# ***Interactive comment on “Radiometric consistency assessment of hyperspectral infrared sounders” by L. Wang et al.***

**Anonymous Referee #2**

Received and published: 10 August 2015

**Figure R1 BT differences varying with FOV distance in the range from 0 to 13.0 km.**

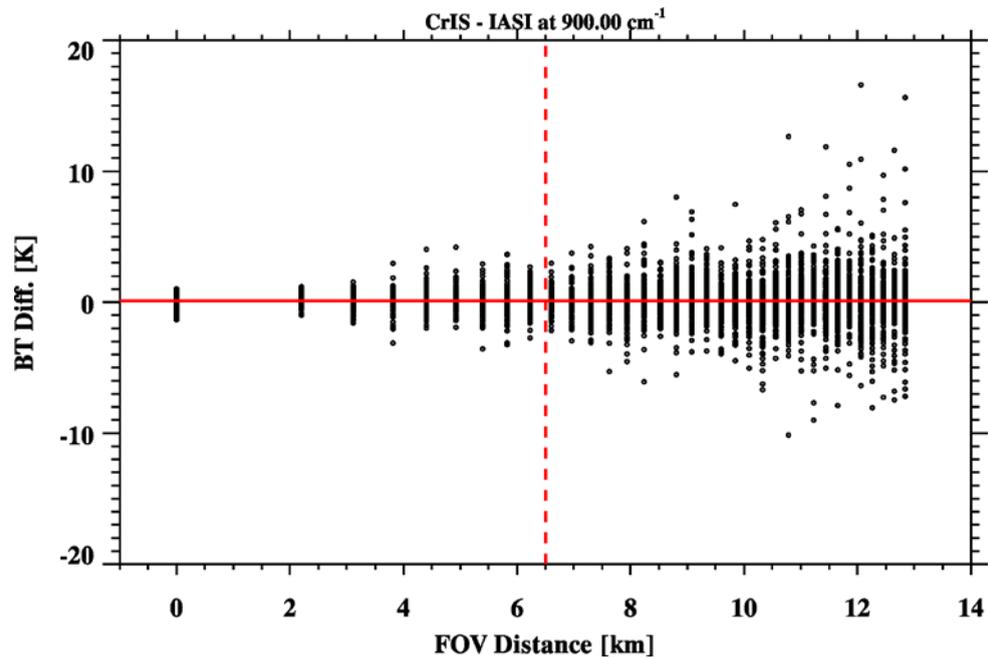
2) The authors also claim that a key feature of this work is the improved accuracy arising from applying tighter coincidence criteria. However, I would have liked to have seen some proof of the importance of this by way of plots showing how the biases and/or scatter change as a function of relaxing the criteria. The criteria used seem to have been arbitrarily chosen and may be too tight in terms of reducing the amount of data available for comparison (with the associated loss of representativeness and geographical coverage, particularly for the IASI comparisons).

**A: Using CrIS-IASI/B dataset as an example, we performed sensitivity tests to check how the BT difference (CrIS-IASI) at  $900\text{ cm}^{-1}$  changes as a function of relaxing the criteria as this reviewer suggested. First, the all the colocated data are filtered by limiting the standard deviation to mean ratio of the VIIRS radiances ( M16) less than 0.05% but relaxing other collocation criteria (FOV distance to 13.0 km, time difference to 10 minutes, no angle limitation at all). Figure R1 shows the BT differences varying with FOV distance in the range from 0 to 13.0 km. Figure R2 shows the BT difference varying with time distance in the range from 0 to 150 seconds. Figure R3 shows the BT differences varying with angle distance ( $\text{abs}(\cos(\text{zen1}))-\cos(\text{zen2}))$ ) in the range from 0 to 0.002.**

Based on the above figures and Figure 5 in the paper, the following conclusions can be drawn. First, the FOV distance and collocation environment uniformity are the major factors that control the scattering pattern of BT differences and sample number. Second, the time differences of all the samples are less than 150 seconds. The 120 second threshold value only filtered out a few points. Third, since we only use the FOVS in two fields of regard (FOR) that have smallest scan angles ( $\pm 1.67$  degree), the CrIS 3X3 FOVs' satellite local zenith angles range from 0.6-3.36 degree and IASI 2x2 FOVs angles range from 1.3-2.7 degree. As a result, all the samples meet the angle difference criteria. We made these points clear in the revised manuscript.
